APPENDIX N

Email Correspondence – Cosgroves

Subject: RE: Karori Village - Wgtn

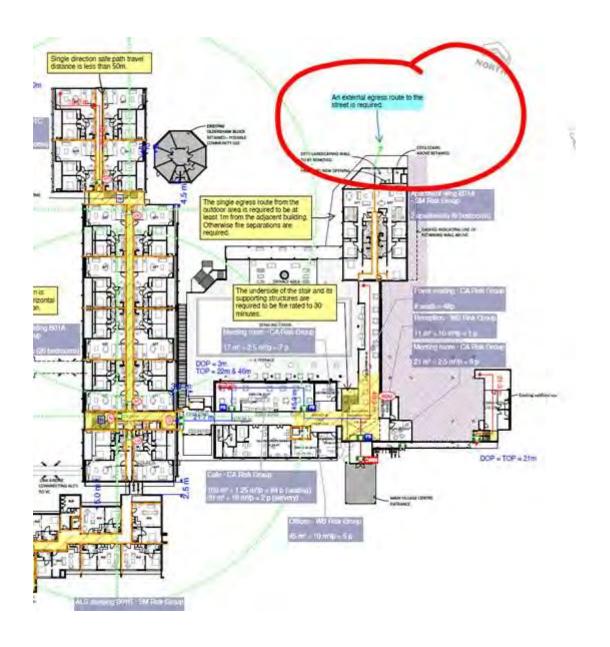
Thank you sending this information through. The gate will not be padlocked, it will have a sensor which automatically opens in the event of an emergency.

The carpark has a 2m wide pedestrian pathway immediately as you exit the gate which then goes out to Donald Street. I have indicated on the image below, the potential egress route – can you please let me know if this is acceptable?

I am just wanting to confirm if the below egress route will still enable cars to be parked along this boundary (it is a Council carpark) and that there is no need to maintain any set clear area in front of the gate.

I just tried calling, in regard to below. If we retain the current fire agrees route adjacent to the car park, can residence muster on the foot path aligning Donald St? Basically we want to avoid mustering on the car park itself.

With regards to the external escape, can you please confirm if the escape route below is achievable?

Can you plse review the fire egrees I have circled below. There are some land ownership & access issues with the adjacent car park, do we have an option to exit at a different location?

The proposed pedestrian pathway is acceptable. Please ensure the occupants have the right to egress on this titled land.

The space can still be used for carparking, but please ensure a minimum 1.2m clear egress route is provided from the point the occupants entering into the carpark until the point the occupants exit the carpark to Donald St. If there is a gate, it shall not prevent occupants to egress to Donald St (i.e. a padlock is not acceptable since a key a required for egress).

As discussed on the phone, the egress route via the carpark and muster on the footpath of Donald St is acceptable from fire engineering point of view.
